#### 186th session

## Proposal for the 05 series of amendments of UN Regulation No. 46

### Submitted by the Working Party on General Safety Provisions \*

The text reproduced below was adopted by the Working Party on General Safety Provisions (GRSG) at its 122nd session (ECE/TRANS/WP.29/GRSG/101, para. 41). It is based on ECE/TRANS/WP.29/GRSG/2021/18 as amended by GRSG-122-08. It is submitted to the World Forum for Harmonization of Vehicle Regulations (WP.29) and to the Administrative Committee (AC.1) for consideration at their March 2022 sessions.

**Figure 1**  
**Example for the measurement by maximum variation**

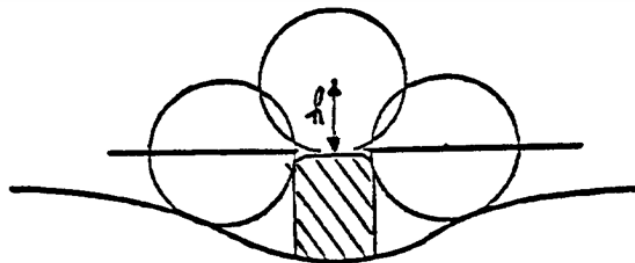
"6.2.2.1.2.2. If the dimension of the projection of a component which is mounted on a surface other than convex cannot be determined by simple measurement, it shall be determined by the maximum variation of the distance of the centre of a 100 mm diameter sphere from the nominal line of the panel when the sphere is moved over and is in constant contact with that component. Figure 1 shows an example of the use of this procedure."

### Arrangement of approval mark of a device for indirect vision

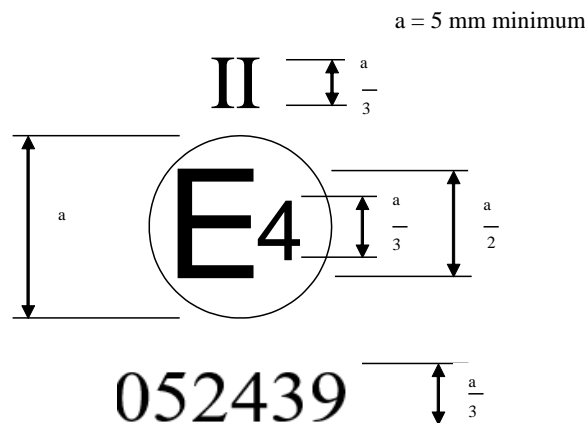
The above approval mark affixed to a device for indirect vision indicates that the device is a main rear-view device, of Class II, which has been approved in the Netherlands (E4) pursuant

to Regulation No. 46 and under approval number 052439. The first two digits of the approval number indicate that Regulation No. 46 already included the 05 series of amendments when the approval was granted.
